**Re: Comments on I-495 and I-270 Managed Lanes Study Draft Environmental Impact Statement/Draft Section 4(f) Evaluation and Joint Federal/State Application (JPA) (USACE Application Number (NAB-2018-02152) and the MDE Tracking Numbers 20-NT-0114 / 202060649)**

On behalf of the undersigned Organizations and their members and supporters, we submit the following comments in response to Notice of Availability of the I-495 & I-270 Managed Lanes Study Draft Environmental Impact Statement (DEIS) and Draft Section 4(f) Evaluation. 85 Fed. Reg. 41,583.

Figure 2-12: I-495 Existing (2017) Inner Loop Peak Period Hourly Volumes

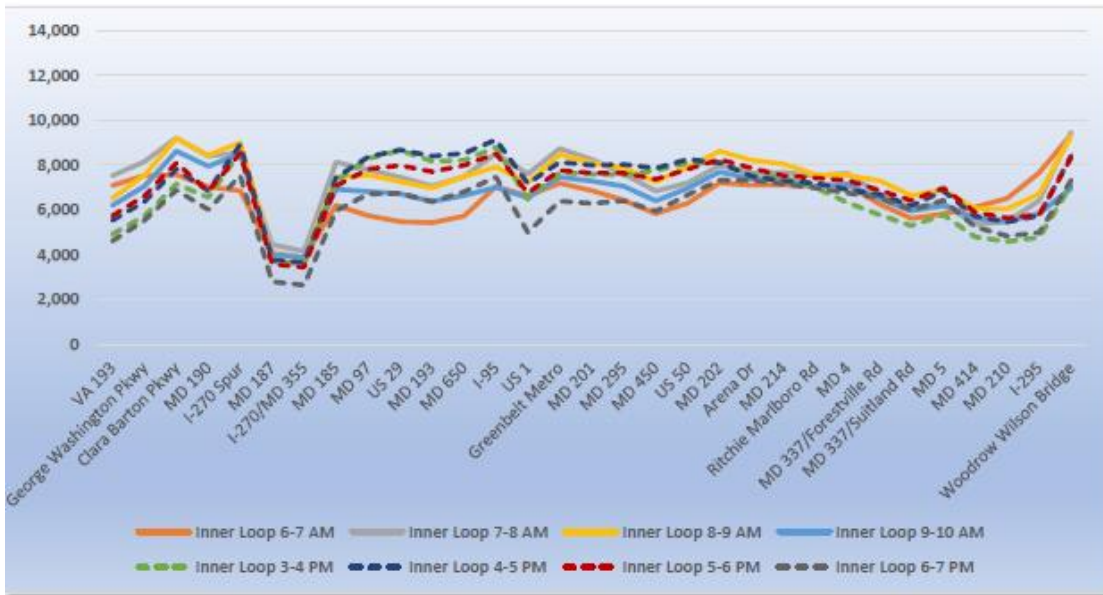
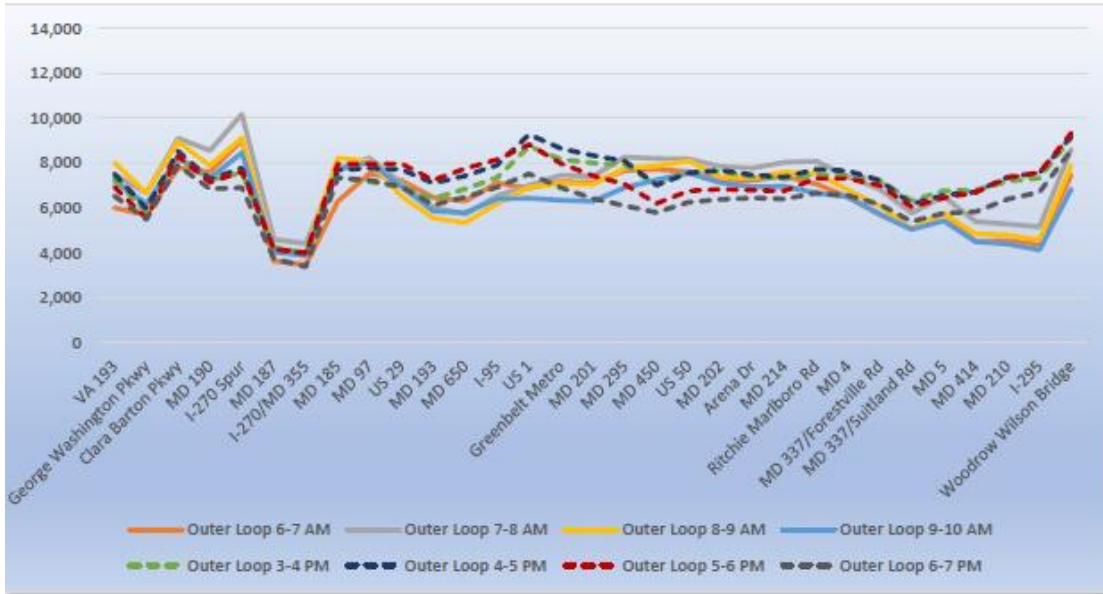
In the DEIS, many segments of I-495, I-270 and other roads are loaded with v/c greater than 1.1 (Figure 2). Horowitz admonishes that the DEIS modeling should not be published with v/c > 1.1. Therefore, these model results should not be used for planning purposes. However, not only does the DEIS publish these modeling results and use them for planning, but it even goes so far as to represent these over-capacity assignments as a performance measure. This claim is false and is rebutted in the Appendix B of this section.

Figure 3: Wildly Impossible Potomac Bridge Traffic Forecasts in MWCOG 2040 No Build Morning and Afternoon Peak Periods

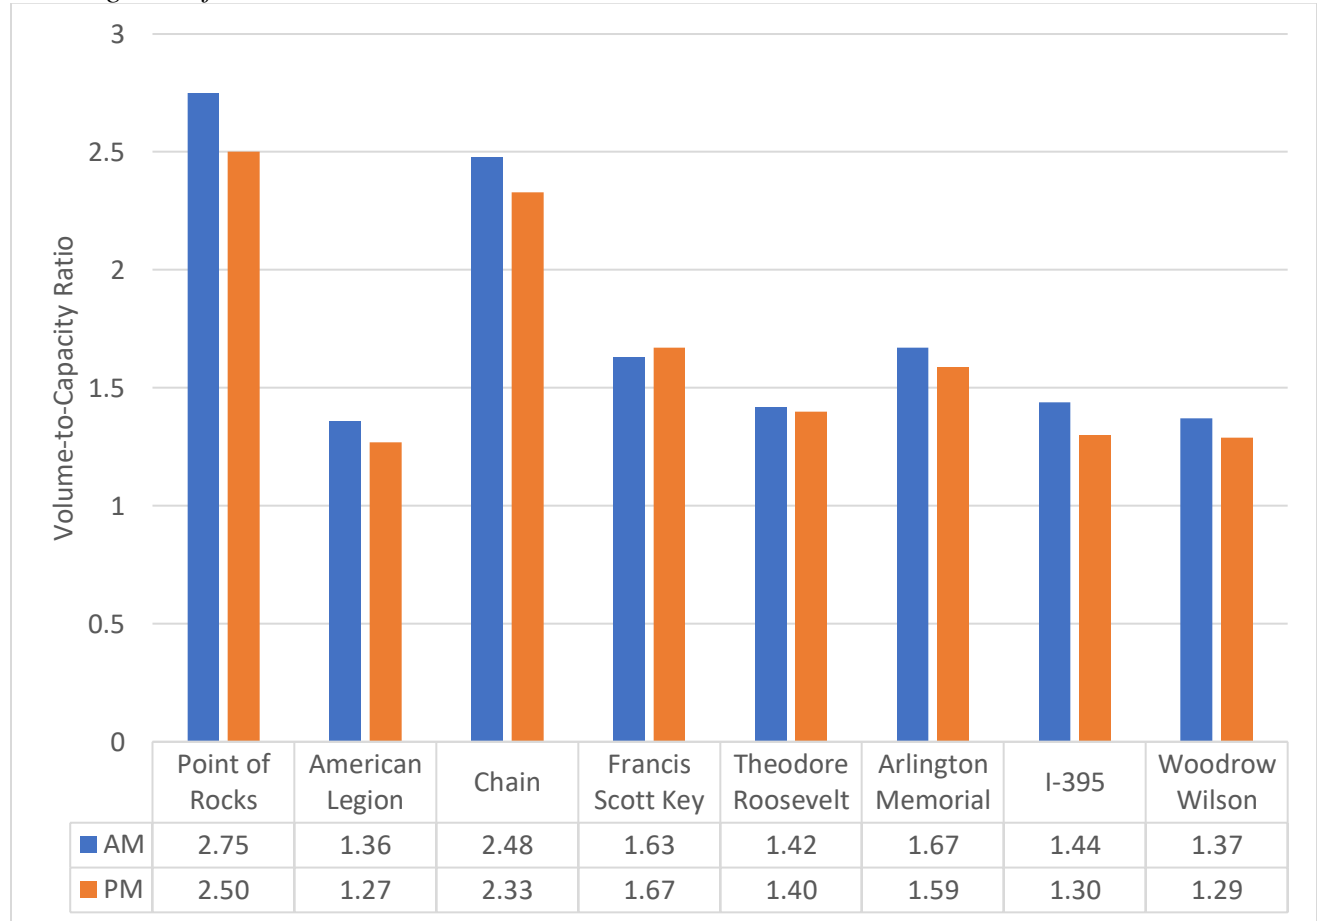
In the DEIS 2040 no build model, MWCOG morning and afternoon peak period traffic volumes for all Potomac River bridge crossings are ridiculously high (Figure 3). All greatly exceed the 1.1 volume-to-capacity ratio threshold, and range as high as 2.75, i.e., the bridge traffic volume is 275% of the highest possible volume.

Figure 8: 2040 No Build Regional Afternoon Peak Period VHD – Road Segments with Possible  $v/c \leq 1.0$  vs. Impossible  $v/c > 1.0$

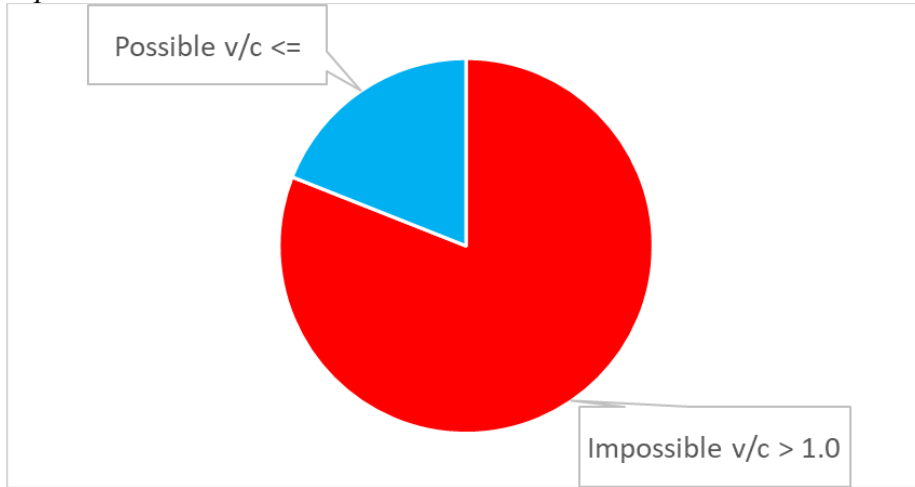
As shown in Figure 8, 81% of regional afternoon peak period VHD in the 2040 no build modeling is from impossible assignments with volume-to-capacity ratio exceeding 1.0. The exponential increases in modeled delay as a function of  $V/C$  makes MWCOG model VHD more of a metric of model errors than a metric of real-world performance.

Figure 10: DEIS “Demand” for American Legion Bridge Inner Loop in the Afternoon Peak Period

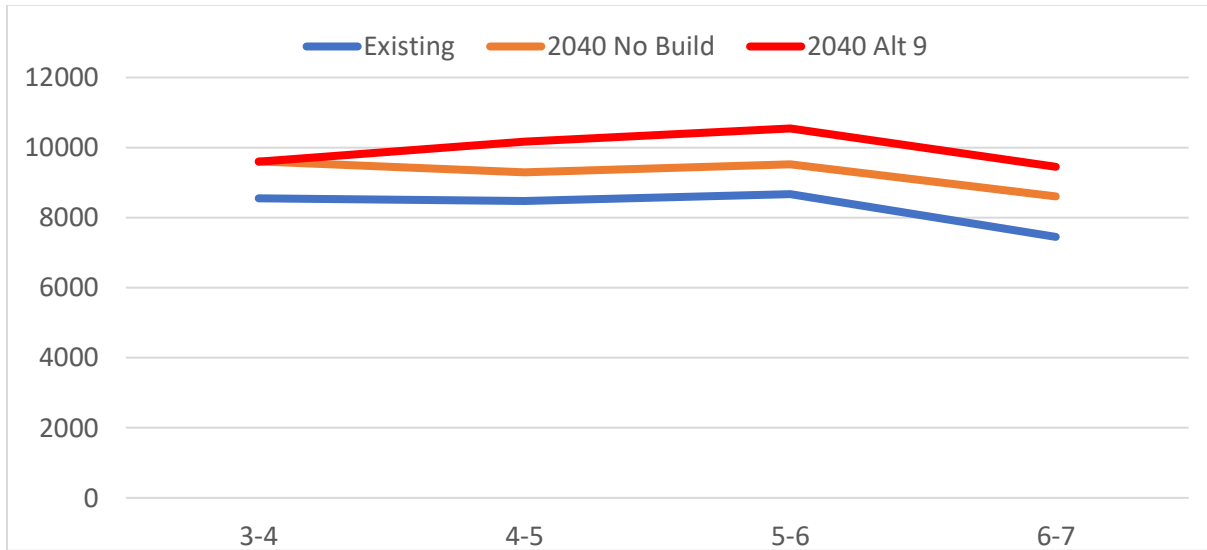
Figure 10 shows afternoon peak period “demand” (vehicles per hour) on the American Legion Bridge Inner Loop from the MWCOG model. Figure 11 shows afternoon peak period “throughput” (vehicles per hour) on the American Legion Inner Loop from the VISSIM model.

The DEIS framing of “demand” vs. “throughput” is fundamentally wrong. Demand is not a point; demand is a curve with more demand when the price is lower and less demand when the price is higher. For un-tolled roads, this “price” is primarily based on the value of travel time. The generalized price for toll roads includes both cost and time. As shown in this illustration from the Federal Highway Administration, there is a market equilibrium balance between demand and price/supply (Figure 12).

Figure 11: DEIS “Throughput” for American Legion Bridge Inner Loop in the Afternoon Peak Period

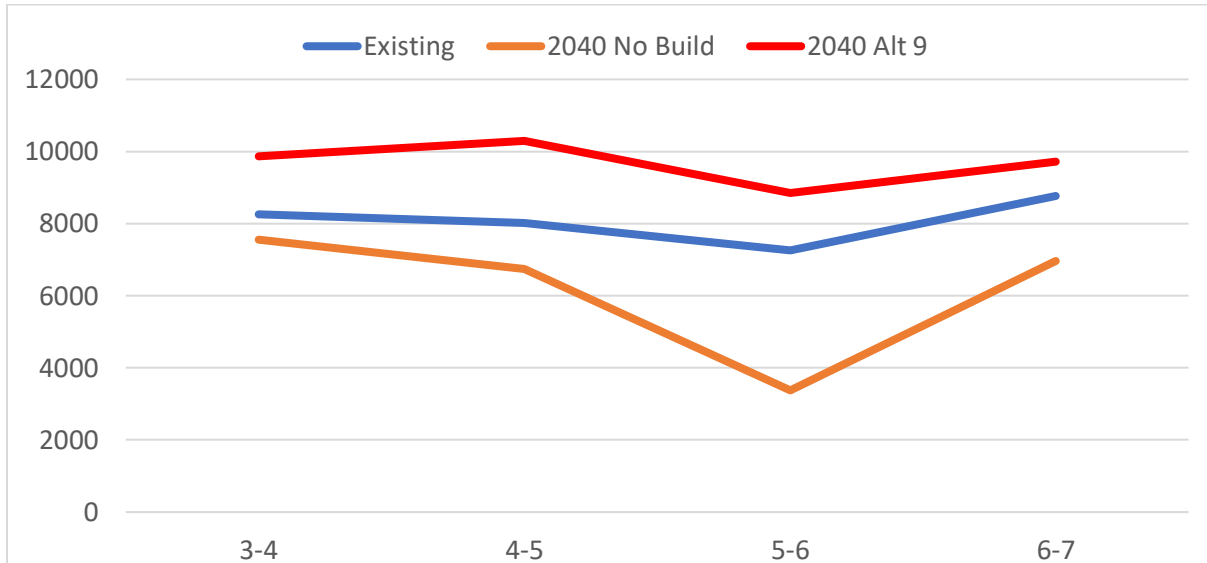
The dichotomy put forward in the DEIS of “demand” vs. “throughput” does not exist. There are only traffic volumes at the equilibrium point. The volume  $V_0$  represents the point on the demand curve where the cost equals  $P_0$ . The “throughput” should equal this equilibrium traffic volume.
